Addendum #2

Project Name: Hastings City Auditorium – Interior Renovation
Hastings, Nebraska
Project No.: AUD-2015-15011C
Issued: December 03, 2015
Bid Date: 10:00am, Thursday, December 10, 2015
Bid Opening: Sinclair Hille Architects
Location: Lincoln, NE 68508

H1 LIGHTING FIXTURE SCHEDULE

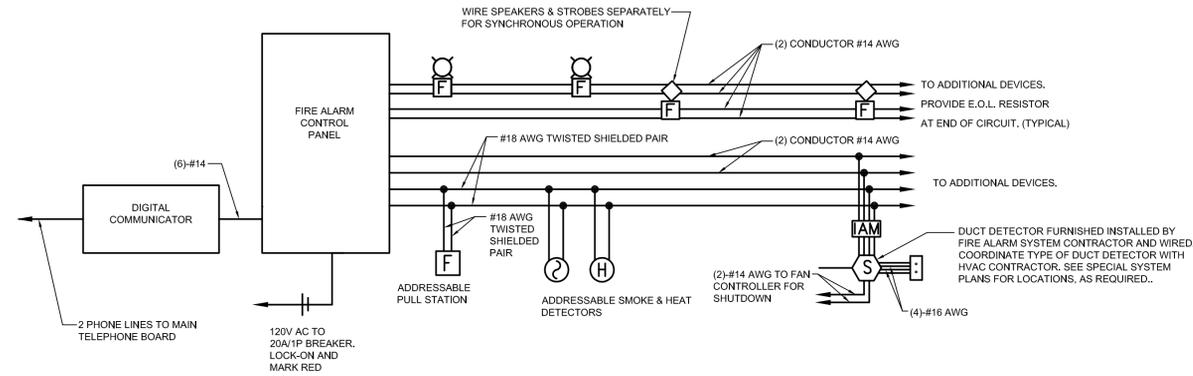
Referencing attached Sheet E402 please note the following modifications:

- Model number for fixture type A1 has been changed to S2532-L48-35K-LF06-BA-OA-180-DIM-SWC
